Plot 23: Unresolved Waterproofing, Drainage and Lawfulness Issues

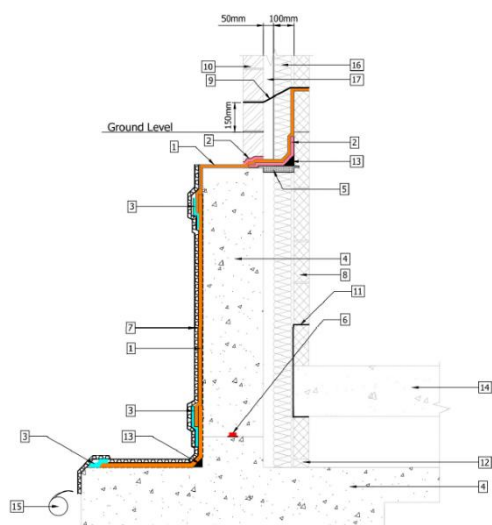
Documents disclosed by Kirklees under FOI reference 41699 include a detailed waterproofing arrangement incorporating a fully bonded waterproofing system on the external, earth-facing side of the concrete retaining wall.

Kirklees must establish whether this detail formed part of the approved planning documents, the Building Regulations submission or another technical specification applicable to Plot 23. The available photographic evidence nevertheless raises serious questions about whether the documented arrangement was followed.

Photographs taken before concealment appear to show areas of the external, earth-facing concrete without the fully bonded waterproofing system shown in the disclosed detail.

The light-grey CM8 Geotextile is visible in some areas. Where it already covers the concrete, photographs cannot reveal what is behind it. However, where the earth-facing concrete remained exposed before the CM8 Geotextile was fitted or backfilling occurred, no fully bonded layer is apparent.

Later photographs do not appear to show the fully bonded system being added to those exposed areas before they were covered or became inaccessible. Construction and backfilling subsequently progressed to the point at which a continuous fully bonded external system could not now be installed in the documented manner without excavation, removal of the CM8 Geotextile and disturbance of later construction.

The absence of a visible membrane in photographs is not, by itself, conclusive proof that no system exists elsewhere. The applicant should therefore be required to produce contemporaneous installation photographs, inspection records and certification demonstrating that the fully bonded system was installed throughout before the CM8 Geotextile and backfill concealed it.

- dated photographs showing the fully bonded system on the external, earth-facing face before the grey CM8 Geotextile and backfill were added;
- the approved or accepted waterproofing specification and construction details;

Apparent inspection before concealment

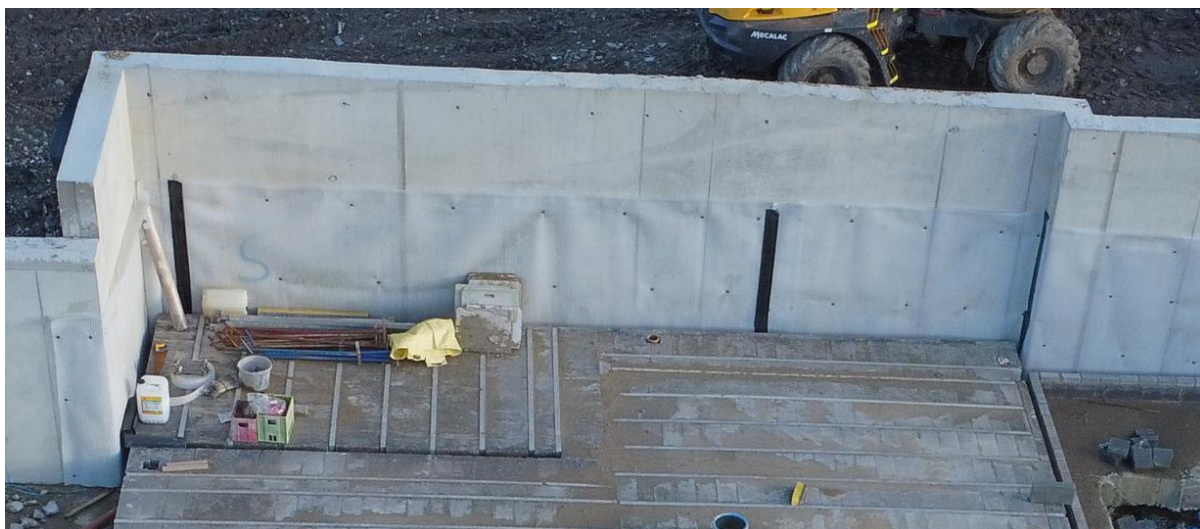
Time-stamped CCTV footage from 1 September 2025, from which the accompanying still has been extracted, shows a person who appears to inspect the retaining works at Plot 23. Within minutes of that person leaving, an excavator begins earth-moving or apparent backfilling in the same area.

The evidence alone does not establish the visitor's identity or the precise purpose of the visit. It does, however, demonstrate how quickly work capable of concealing the external waterproofing and drainage arrangement followed the apparent inspection.

Kirklees should identify the visitor, the purpose and scope of the visit, what was inspected, whether the external face and fully bonded system were visible, what records or photographs were produced, and what evidence was relied upon before backfilling proceeded.

- the identity of the visitor, purpose and scope of the apparent inspection on 1 September 2025, together with all inspection records, photographs and evidence relied upon before backfilling;
